Appendix A

Comments and Responses

Table A-2. Responses to Comments Received During the Klamath Drainage District Watershed Plan-EA Public Comment Period

Figure C-12. Tax lots associated with the North Canal Extension Project.

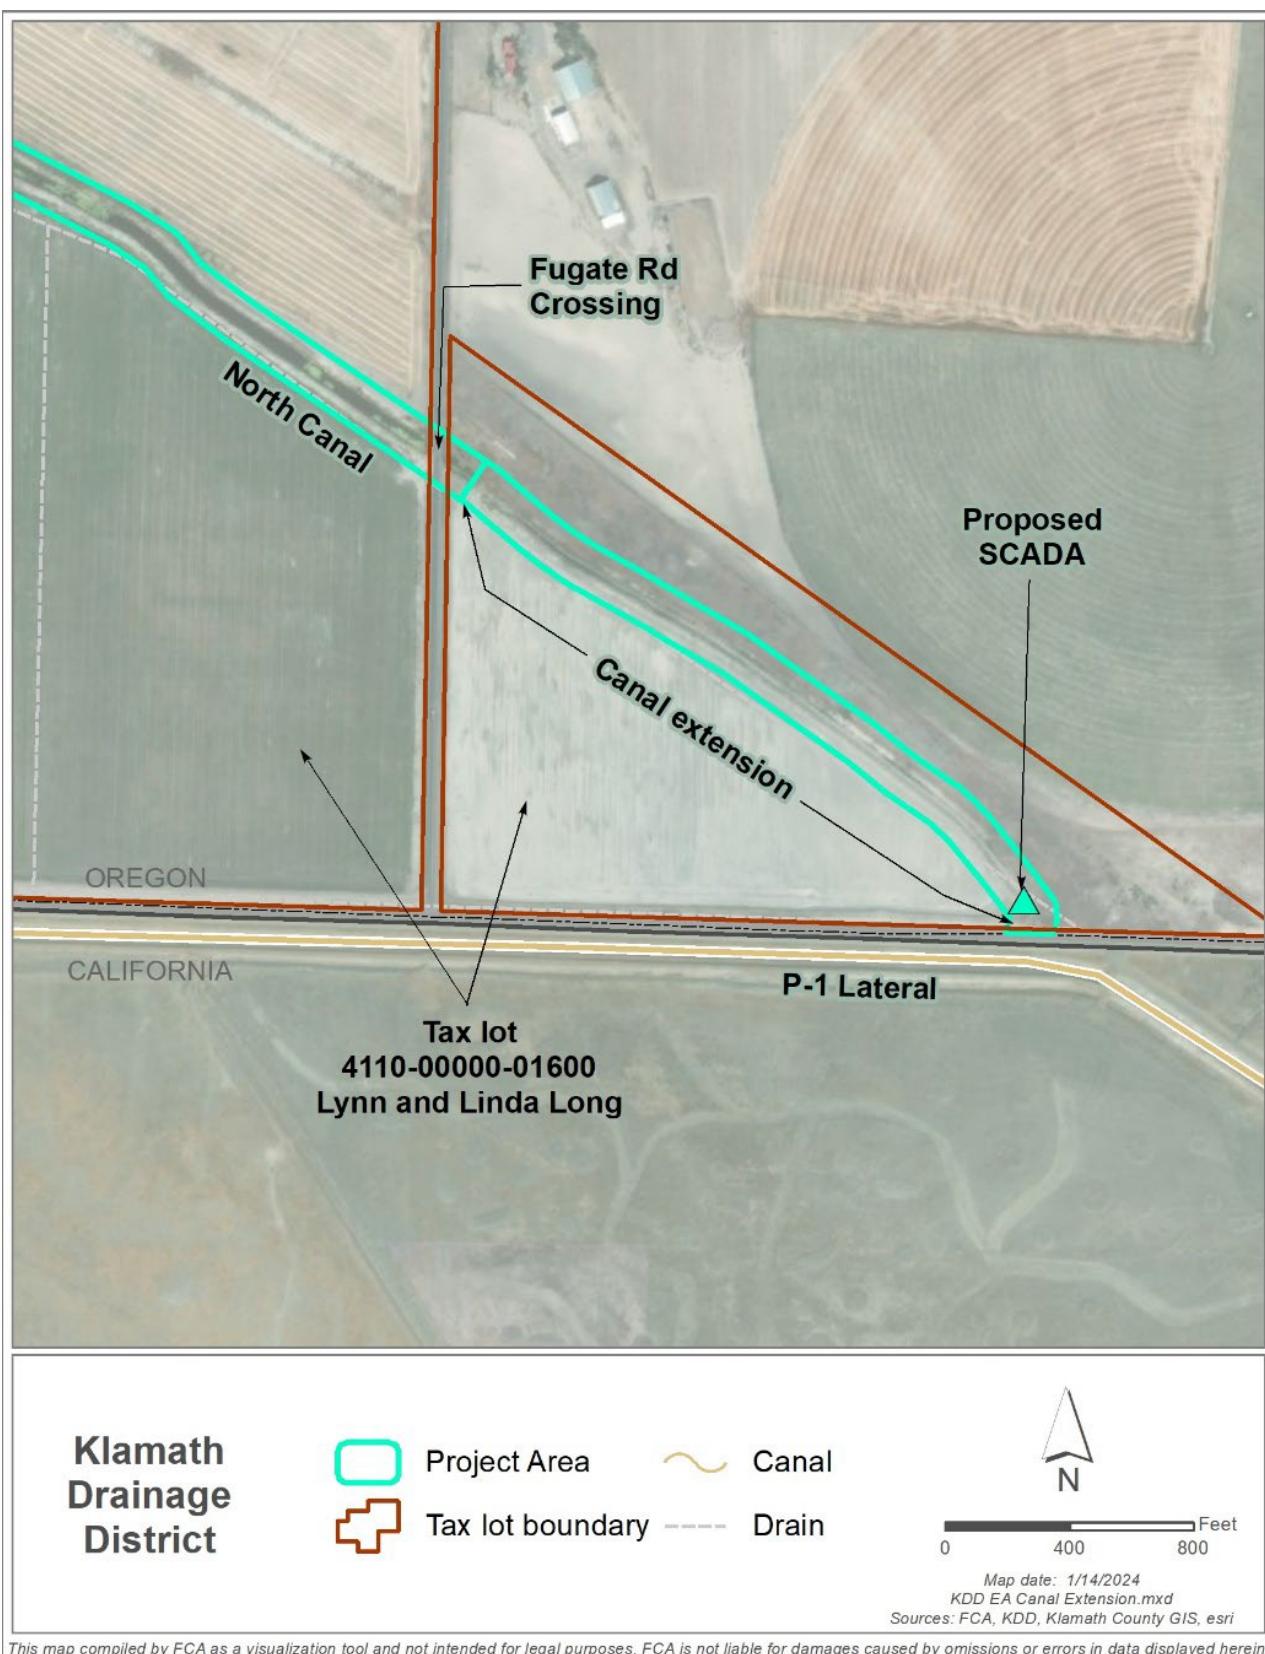
<p>permitting process, a wetland and waters delineation by a qualified wetland professional is needed for the North Canal extension to P-1 Lateral (Figure C-12) and the fish screen installation/levee break repairs at the North Canal intake (Figures C-2 & C-14). A wetland delineation report should then be submitted to DSL for review and approval. After the boundaries of waters of this state are established in these areas, please contact Mike Schmeiske (michael.schmeiske@dsl.oregon.gov, 541-388-6162) to discuss avoidance and minimization of impacts prior to submitting a Removal-Fill permit application.</p> <p>Thank you for the opportunity to comment. We look forward to working with the District and partners in the future</p>
